Environmental
Protection Agency

July 11, 2011

RE: WAYNE COUNTY
CHIPPEWA TOWNSHIP
CHIPPEWA CREEK RAW WATER
MAIN & WELL FIELD
CONSTRUCTION STORM WATER

Figure 1 – Some areas near the well field lack stabilization.

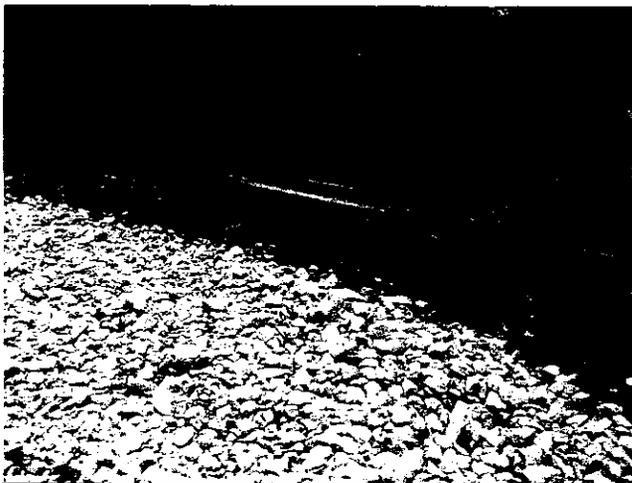
1. Some areas of the well field and drive (Contract F) still lack vegetation. Please seed and mulch these areas and monitor the growth of vegetation to ensure that the site reaches final stabilization. Once the site is stabilized and reaches a 70% vegetative cover, the silt fence may be removed. Until then, please continue to maintain the silt fence so that it will effectively filter the runoff from the site.
2. While inspecting the length of the pipeline, I spoke with several workers who were preparing the ground for seeding. Please ensure that the entire length of the project is seeded and mulched as soon as possible. If any areas will not be stabilized within a reasonable amount of time, you must install silt fence around these disturbed areas to prevent sediment from leaving the site.
